**NTPC Limited**

Ref No. 01.CD.737-D

Date: 15.05.2020

**Subject:** Comments of NTPC on Draft CERC (Terms and Conditions of Tariff)(First Amendment) Regulations, 2020

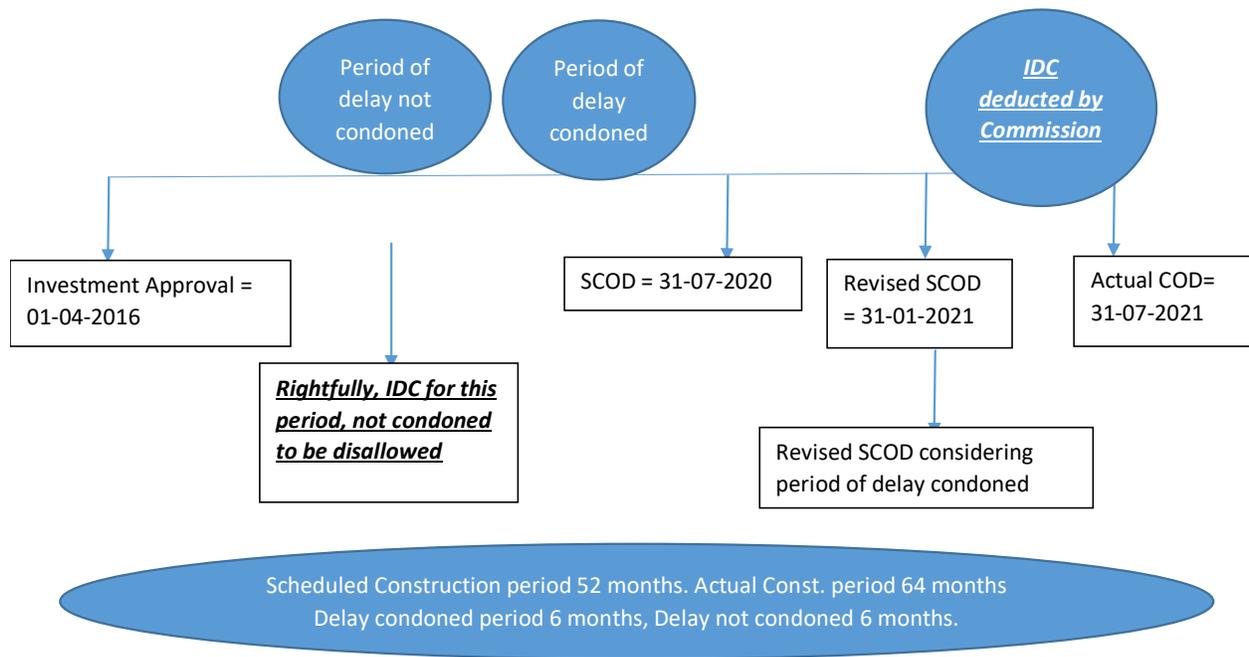
**Comments:** It is submitted that there seems to be typographical error in the revised clause 5.1 and perhaps Clause(2) of Regulation 14 was intended to be referred to instead of Clause 2 of Regulation 8. The same may be clarified.
